GFA AIRWORTHINESS DIRECTIVE

TYPES AFFECTED: H 401 Kestrel
T59 Kestrel all variants
H301B Libelle
Standard Libelle
Standard Libelle 201B

SUBJECT: Cracking of the lower rudder hinge/control yoke.

TECHNICAL NOTE NO. 401 - 19

301-45-13

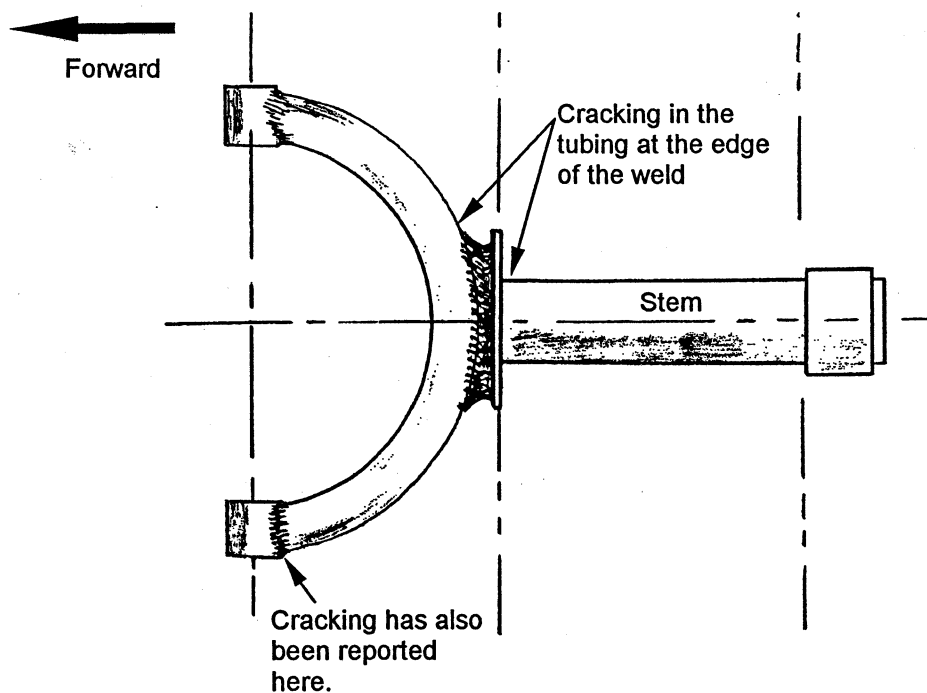
Only genuine parts made in accordance with
drawing No. 301-45-13 must be used.

Actions : The faulty part, made according to drawing No. 301-45-10,
must be replaced by an improved actuator arm, made in
accordance with drawing No. 301-45-13.

3. Types H 401 Kestrel and T59 Kestrel all variants must be fitted with improved actuator arm according to Technical Note No. 401-19.
